PHILADELPHIA ELECTRIC COMPANY

SUBJECT: Limerick Generating Station, Units 1 and 2
Peach Bottom Atomic Power Station, Units 2 and 3
Response to Request for Additional Information
Concerning Proposed Combined Emergency Operations
Facility

RESPONSE TO OCTOBER 6, 1989
NRC REQUEST FOR
ADDITIONAL INFORMATION

PROPOSED COMBINED
EMERGENCY OPERATIONS FACILITY (EOF)
STAFFING PLAN

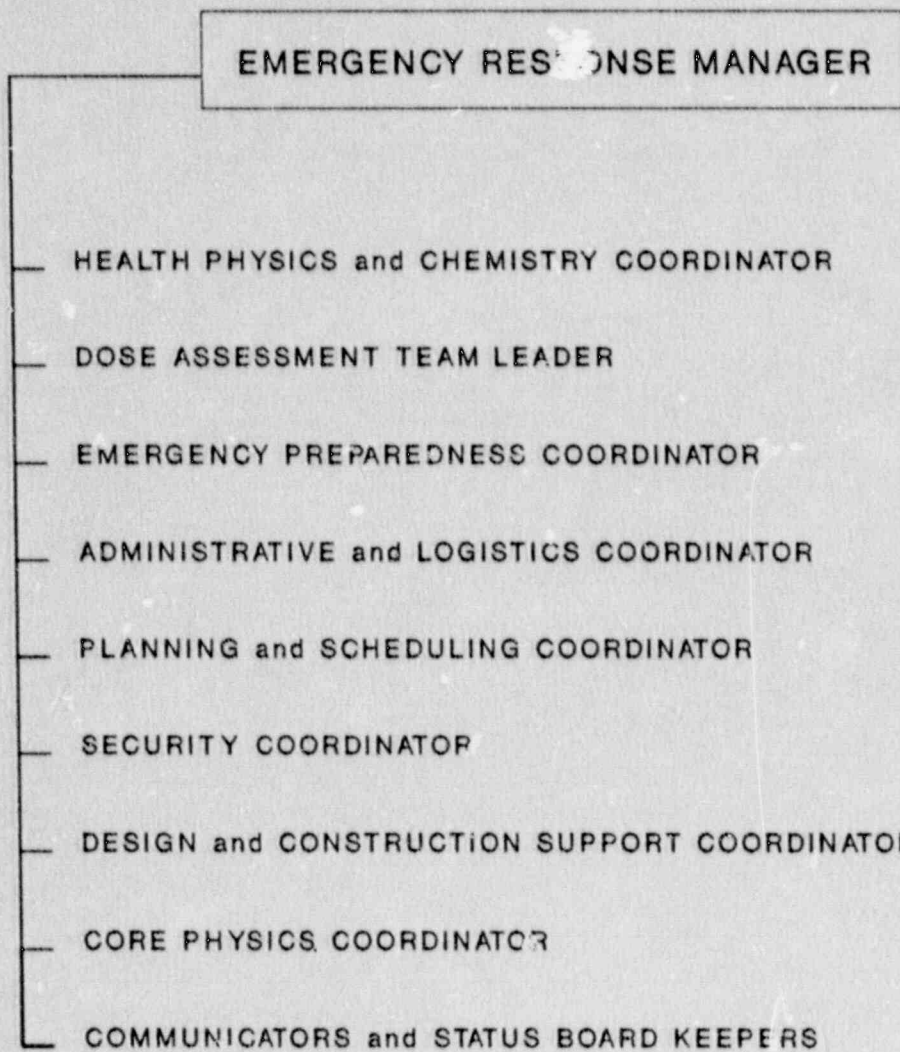
1. Provide the proposed staffing plan for the new EOF. List the proposed staff by title, indicating where they work (corporate office or at one of the plants) and where they live in relationship to the proposed EOF (miles and travel time).

The proposed staffing plan for the Coatesville EOF would involve combining the personnel and capabilities of the existing LGS and PBAPS EOFs, and the Headquarters Emergency Support Center located in Philadelphia. The proposed EOF could be adequately staffed by the key emergency response organization personnel within 60 minutes in accordance with the direction of NUREG-0696, "Functional Criteria for Emergency Response Facilities." This staffing plan also utilizes the support staff call-out ability to meet additional staffing commitments. Attachments are provided detailing specific information regarding the EOF staffing plan. The attachments identified below provide the necessary information regarding EOF staffing, travel times, company organizational positions, and work location relationships.

- o Attachment 2 - Proposed EOF Staffing Plan
- o Attachment 3 - Proposed EOF Staffing and Corresponding Company Organizational Positions and Work Locations
- o Attachment 4 - Proposed EOF Staffing Travel Times
